APPLICATION NUMBER: 25/0798

PROPOSAL: **CONDITION 2 (LANDSCAPING AND TREE PLANTING SCHEME) OF 25/0188 FOR PROPOSED ALTERATIONS TO VEHICULAR ACCESS, CONSTRUCTION OF ENTRANCE GATES AND PIERS**

SITE: **Golynos Fach Farm Golynos Lane Rogerstone Newport NP10 9GR**

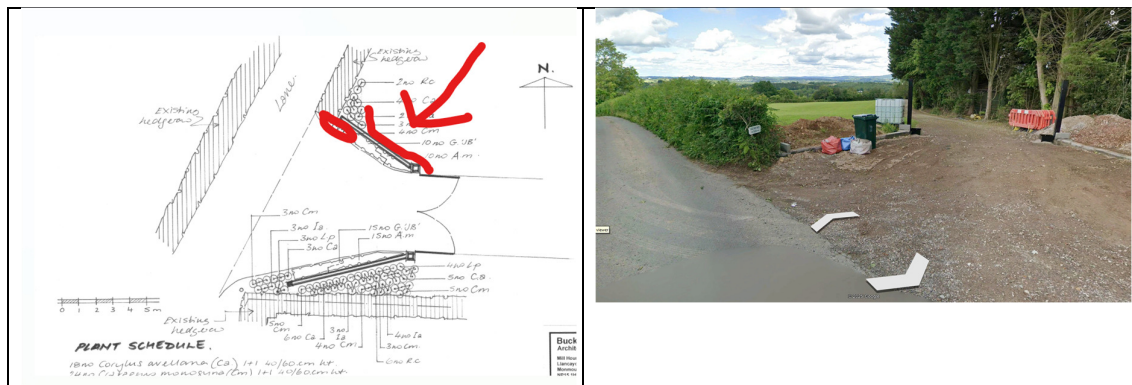
The applicant should refer to Highways comments for 25/0188 which was seeking to 'not reduce' visibility along Golynos Lane and to use low planting – I would suggest this translates into removal of proposed hedge species at south end of north section existing hedgerow as I have highlighted below.

I would recommend the hedgerow is continued north of retaining wall into field to soften rear of wall onto open field as highlighted above. In the decision notice para 8.11 "The applicant has stated that it is proposed to introduce planting in front of the wall, including the use of wild flowers to the field side, to create both a visual and diverse approach to the landscaping. The field side will be sown with a wild flower mix, locally sourced". Either approach would be OK, although a hedgerow is preferred and will be easier to maintain than a very small areas of wildflower/wildgrass mix.
